Burners

Purpose:

To alert customers to known mechanical problems with burners and to provide recommendations for corrective action.

Figure 1 Inner and outer registers.

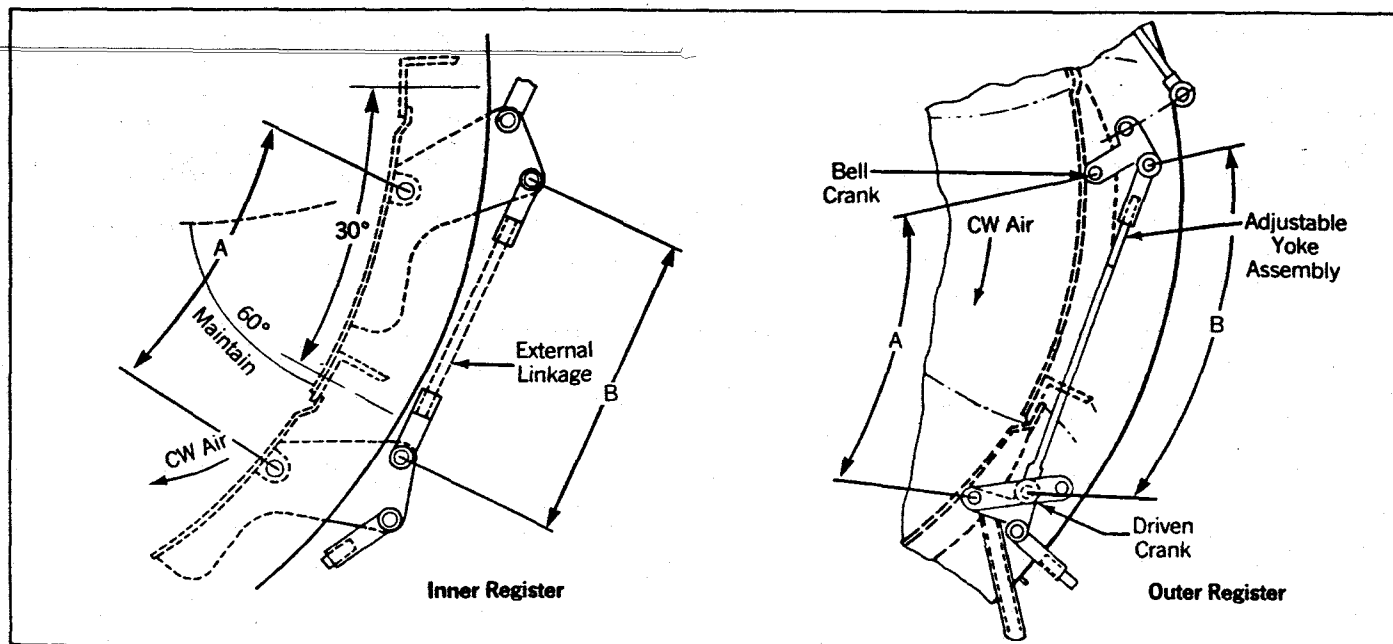
Register doors bind on
Dual Register Burners.

Linkage is improperly
adjusted.

Adjust register door linkage as follows:
Adjust length of linkage (Figure 1) so that distance, center to center, between pins is equal to distance, center to center, of door shafts on linkage (distance A is equal to distance B). Distance between door shafts may vary with different blades.

Figure 2 Typical register blade.

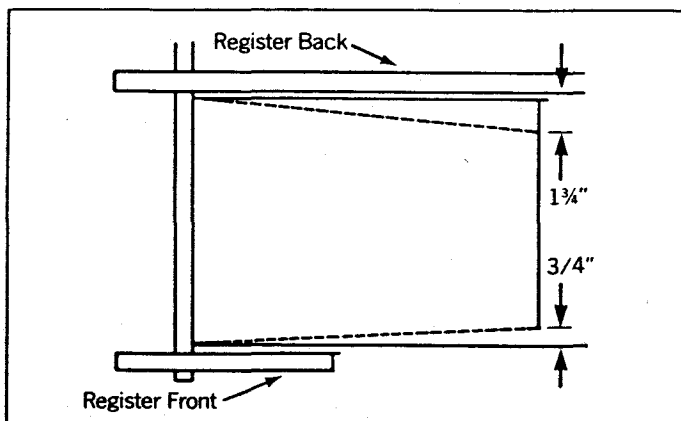
Front plate and/or back plate
warping.

1. Trim register blade to clear front and/or back plate (Figure 2). Install thermocouples to set minimum cooling air.
2. Upgrade registers with H.D. register assembly for better reliability (Figure 3). An engineering review is recommended when a major modification is considered.

Figure 4 Coarser gear.

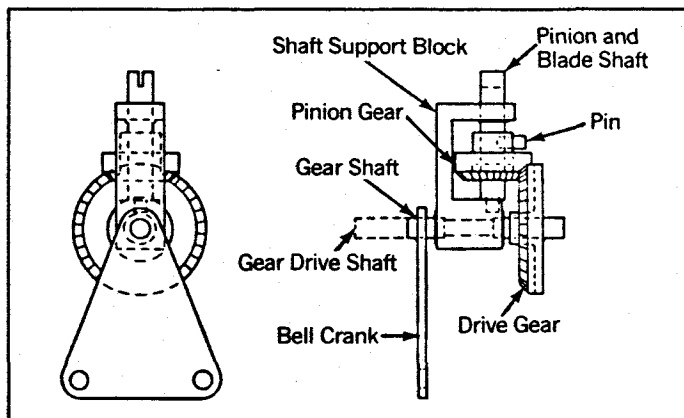
Spin vanes bind on Dual Register Burners

Ash is adhering to gear teeth.

1. Replace existing spin vane drive gears with new (coarse) design (Figure 4). This will minimize fly ash problem.
2. Do *not* use oil base lubricants on gears or register linkages. A graphite base lubricant is recommended, and only when necessary.

Figure 5 New quadrant.

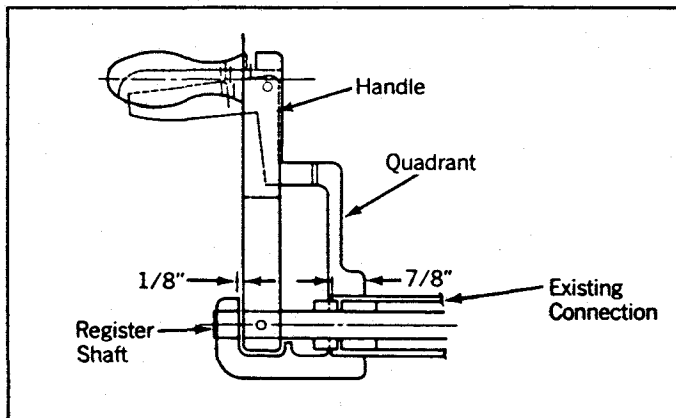
Register position reference lost.

Quadrant unscrews from threaded connection on windbox.

Replace aluminum quadrant with cast steel quadrant (Figure 5). The cast steel quadrant slips over existing threads. Set register position reference and weld new quadrant to threaded wind box connection after matching actual register position with quadrant position.

Figure 6 Typical repair for burner backplates.

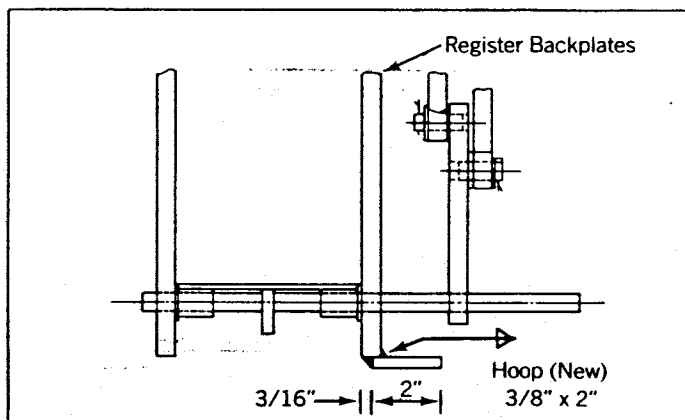
Burner backplate overheats, distorts and warps.

When burners are out of service, cooling air may be insufficient to cool burner backplates

1. Straighten backplate and add a hoop to reinforce it (Figure 6).
2. Install permanent thermocouples on register and burner to determine if cooling air to out of service burner is adequate (Figure 7). Monitor thermocouples and adjust cooling air by using compartment dampers to keep burner cool.

Figure 8 Slip seal plate modification (see Figure 7 for Location).

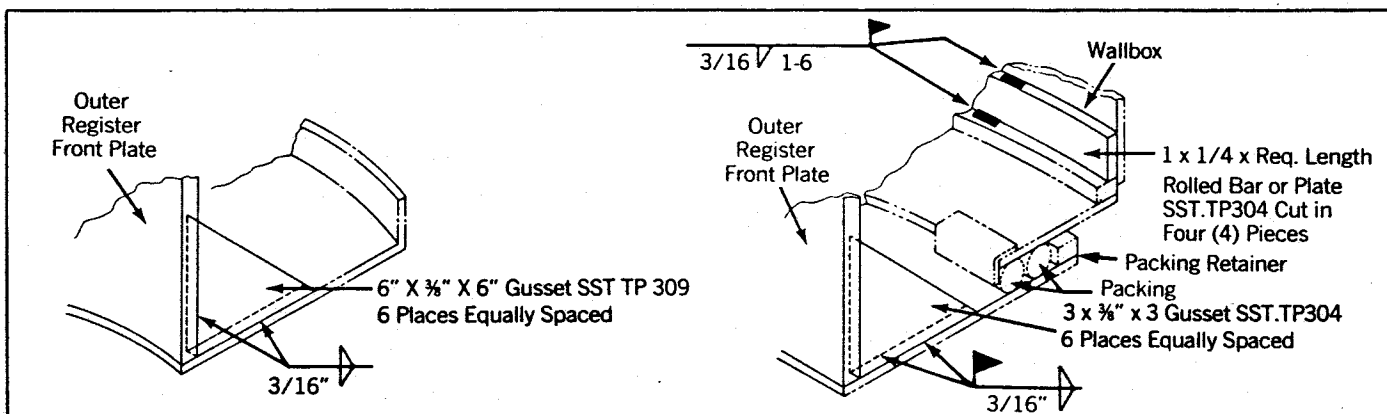
Air bypasses burner register assembly.

Register assembly warps. Front wall seal plate connection fills with debris and does not allow proper expansion movement.

Trim seal plate and add several rows of packing and a packing retained plate (Figure 8). Fiberfrax 2300 is recommended for packing. It retains its tensile strength while hot.
